**World Forum for Harmonization of Vehicle Regulations****Working Party on General Safety Provisions****125th session**

**Event Data Recorder:****UN Regulation No. 160 (Event Data Recorder)****Proposal for Supplement 2 to the 01 Series of Amendments to  
UN Regulation No. 160 (Event Data Recorder)****Submitted by the expert from the Informal Working Group on Event  
Data Recorder / Data Storage System for Automated Driving \***

**Corridor +/- 10 Per Cent of the Full-Scale Range of the Accelerometer**

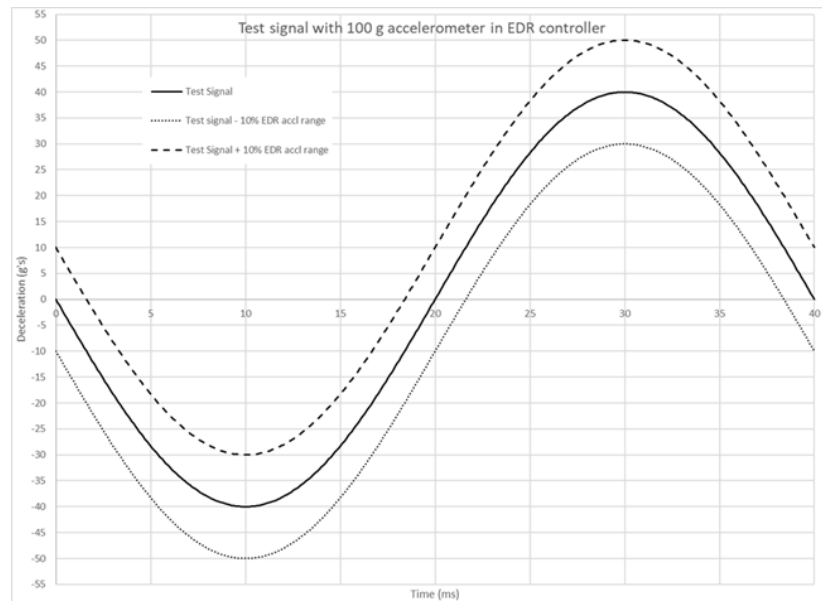
- 6.1.5. The EDR recorded acceleration trace shall be fully contained in a corridor that is +/- 10 percent of the full-scale range of the accelerometer used by the controller containing the EDR applied to the component test fixture's filtered acceleration trace. The comparison of acceleration sensor traces shall only be made on the axis the component test was conducted.

For example, if the accelerometer in the controller containing the EDR function has a +/- 100 g range, then +/- 10 g would be applied to the component test fixture's filtered acceleration trace. The EDR recorded acceleration trace shall be fully contained within that corridor (see the Figure).

- 6.1.6. **The EDR acceleration trace in paragraph 6.1.5. can be time shifted up to +/- 2ms based on the inverse of the 500 Hz sample rate to further align the data. The minimum step of the time shift may be the inverse of the sample rate of the EDR.**
- 6.1.7. **The acceleration data elements satisfy the tolerance condition if the EDR recorded acceleration trace is fully contained within the corridor established in paragraph 6.1.5., with or without following the above time shift in paragraph 6.1.6.**
- 6.1.8. **If the recommended waveform cannot realize algorithm wakeup due to the reason of manufacturer’s algorithm strategy, the manufacture may select a waveform, or amplify the suggested waveform. The waveform used for the EDR acceleration data accuracy shall be provided for review, if it is different than the waveform defined in the verification process."**
